BRUSHCUTTER ATTACHMENT BCA850
(967185901)

Illustrated Parts List - IPL Update

BCA850

A BCA850
ATTACHMENTS

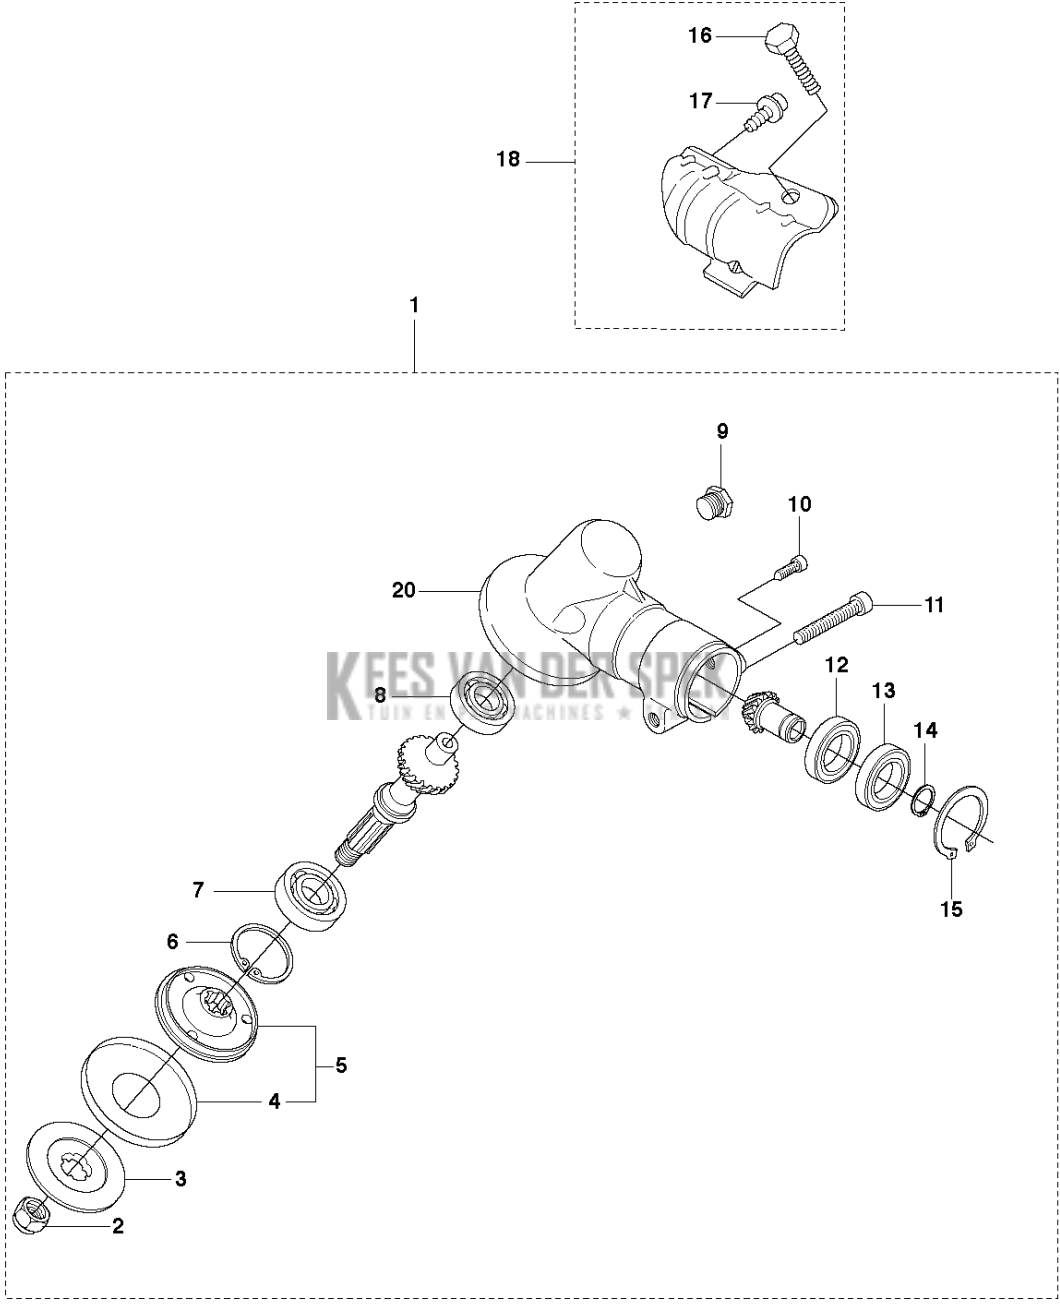
New tube assy, with updated plug, drive shaft and a clip, for an easier assembly (Click-on function)

Drive shaft 587 41 17-01 and plug 587 41 46-01 are backward compatible.
NOTE: Clip 583 93 83-01 does not fit with plug 544 37 87-01 and drive shaft 537 01 19-01.

Page title	Ref. no	New part no	Name	Excl. part no.	Remark
Attachments	1	587 98 81-01	Tube assy	537 07 99-02	
Attachments	4	587 41 46-01	Plug	544 37 87-01	
Attachments	6	587 41 17-01	Drive shaft	537 01 19-01	
Attachments	26	583 93 83-01	Clip		New part
